From: Andrea Grenier [Andrea@agrenier.com]
Sent: Thursday, April 25, 2013 2:31 PM
To: Stora, Christine@Energy
Cc: Scott Galati; Martin-Gallardo, Jennifer@Energy
Subject: RE: Natural Gas Pipeline
Attachments: PSEGS Revised Natural Gas Pipeline Description.docx; Relocated Natural Gas Pipeline Drawing.pdf

**Subject: RELOCATED NATURAL GAS PIPELINE DRAWING
PALEN SOLAR ELECTRIC GENERATING SYSTEM
DOCKET NO. (09-AFC-7C)**

**AMENDMENT
FOR THE PALEN SOLAR ELECTRIC
GENERATING SYSTEM**

Project:	PSEGS	
Date:	March 15, 2013	Figure No: 2.1-6
Revision:	C-1000	
Prepared By:	NS

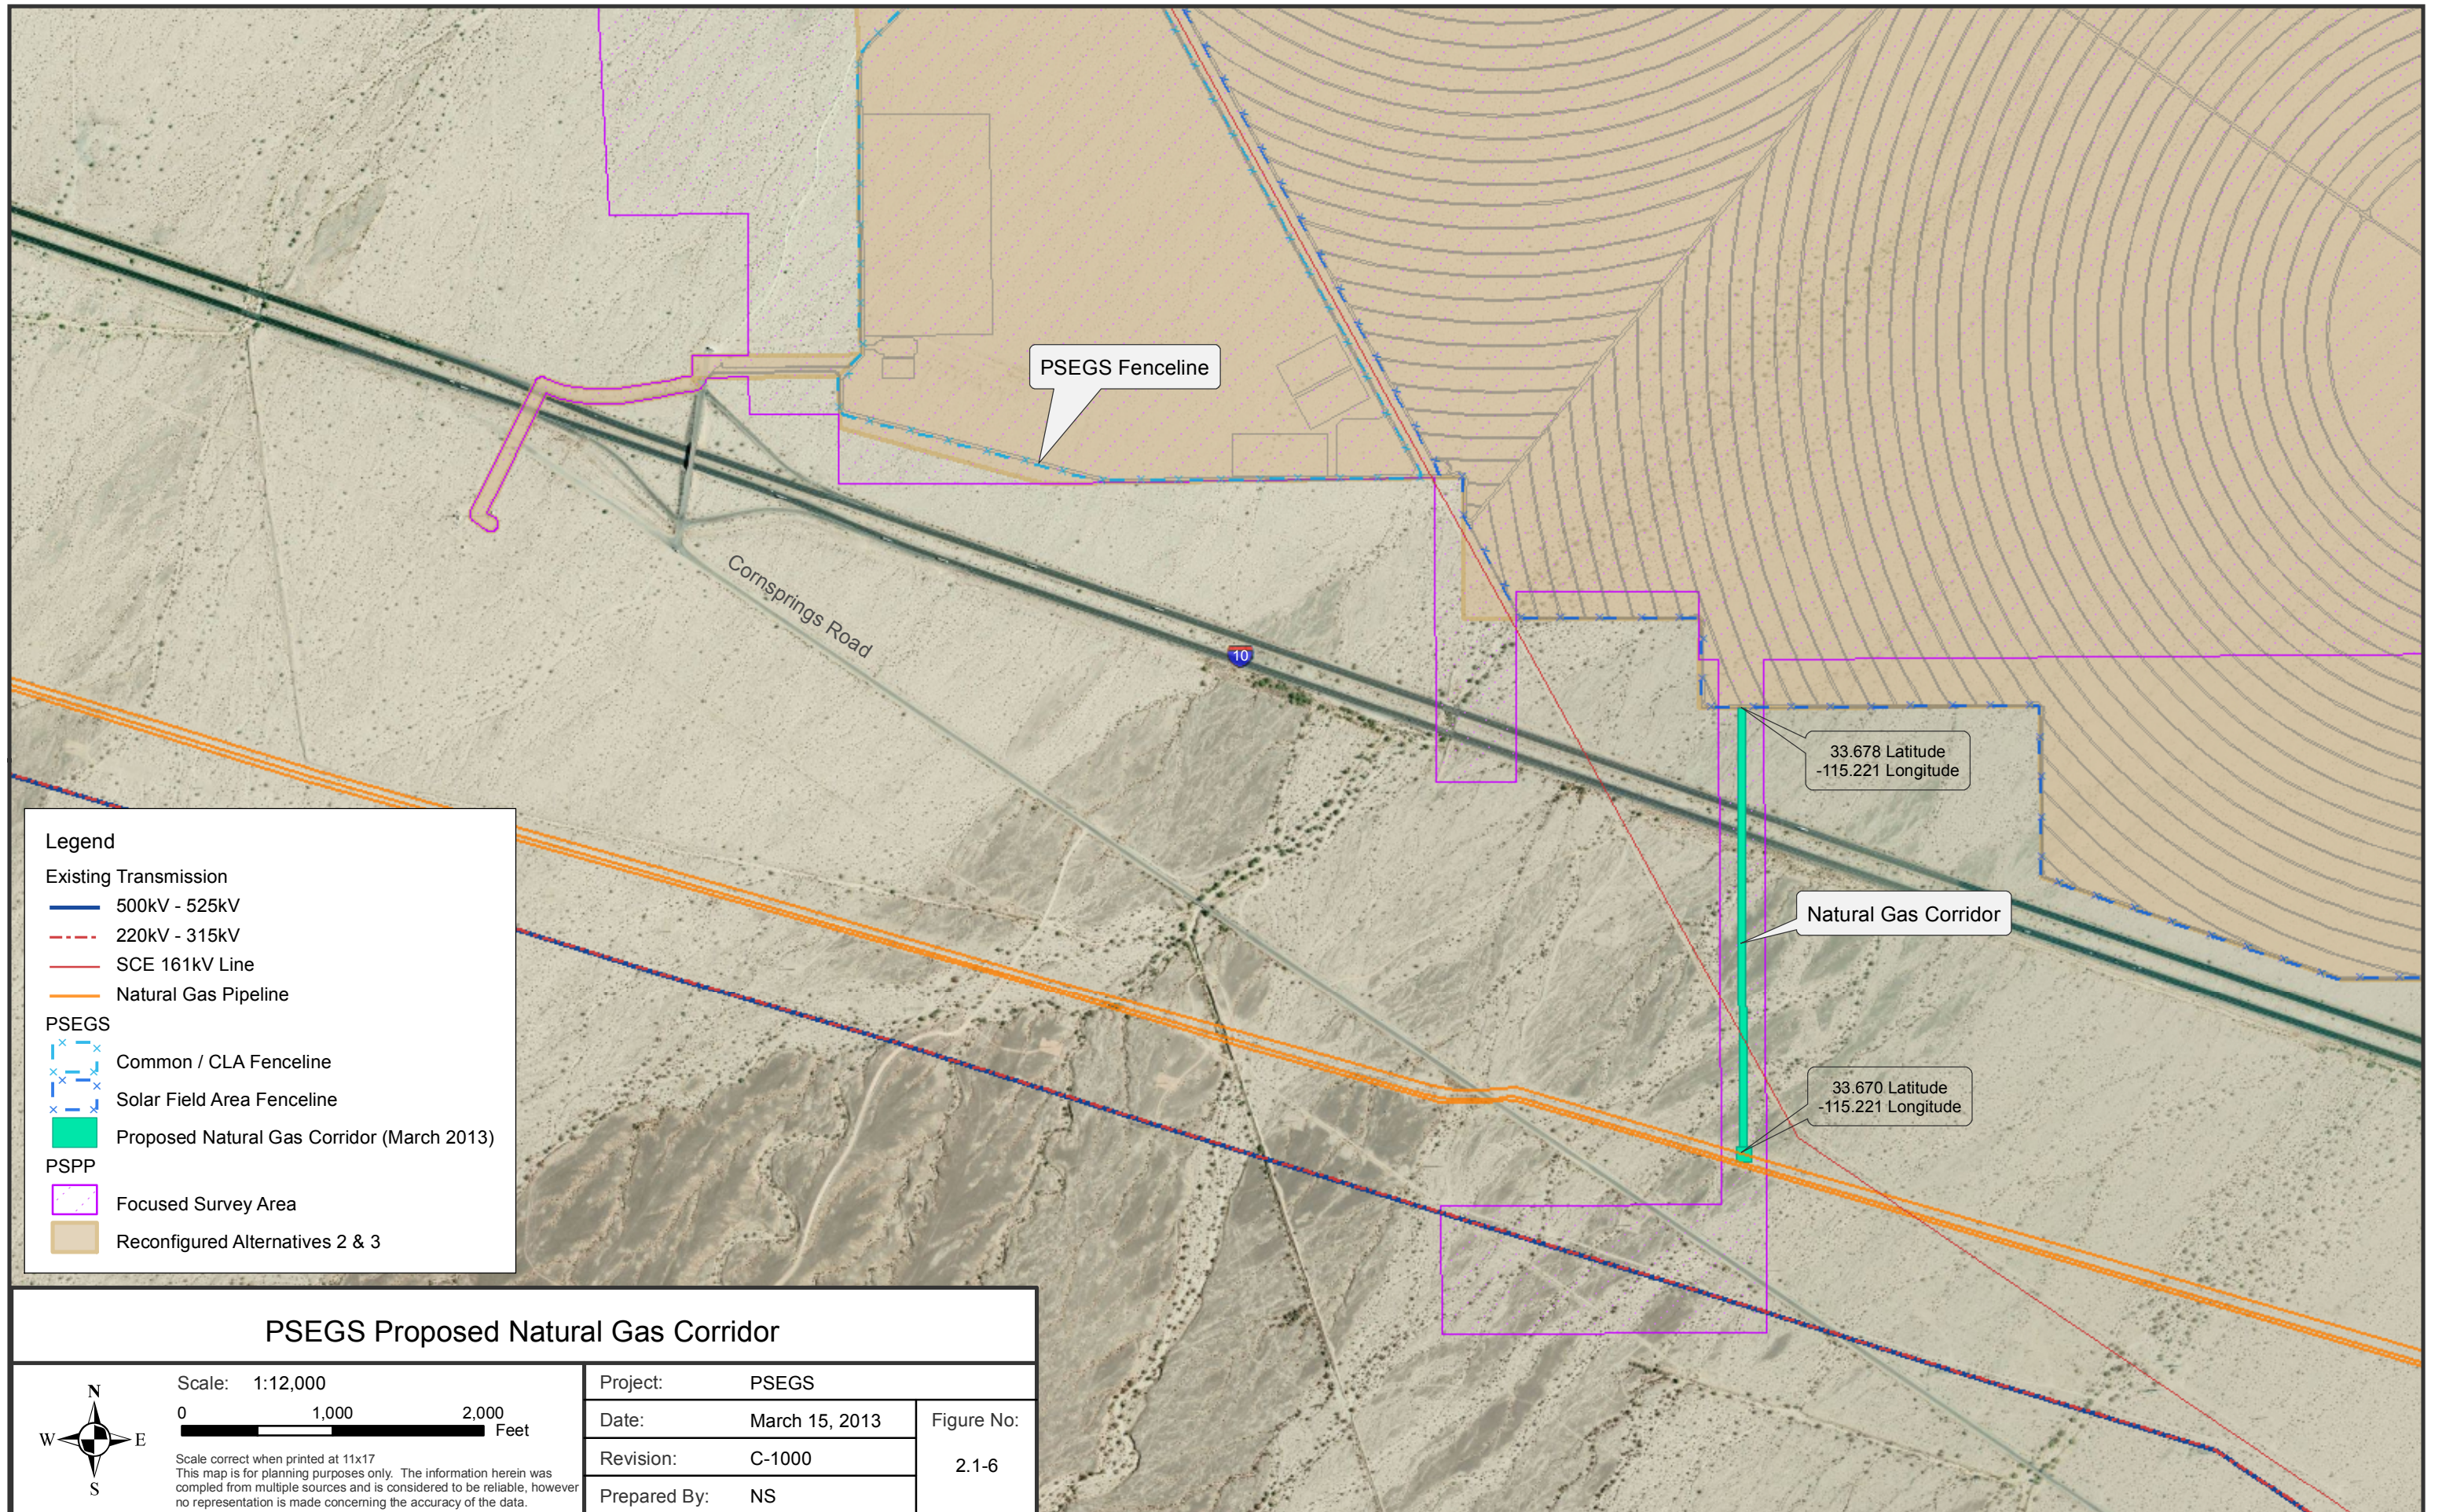
I need to get a revised project description for the gas pipeline based on the revised map that you provided. What we have right now reads as follows:

The Approved Project did not include a natural gas supply pipeline but rather was approved to use LPG for its auxiliary fuel. The Modified Project will use natural gas to fire its auxiliary and nighttime preservation boilers. The natural gas supply for PSEGS will be provided by SoCal Gas via a new pipeline that will extend southward from the site and interconnect with an existing SoCal Gas transmission pipeline located just south of I-10. The new gas pipeline will be approximately 8-inches in diameter and will be approximately 2956 feet long and will be constructed within a previously surveyed corridor as shown on Figure 2.1-6, dated and docketed on March 15, 2013. SoCal Gas will construct, own and operate the new gas pipeline as part of its extensive gas supply system.
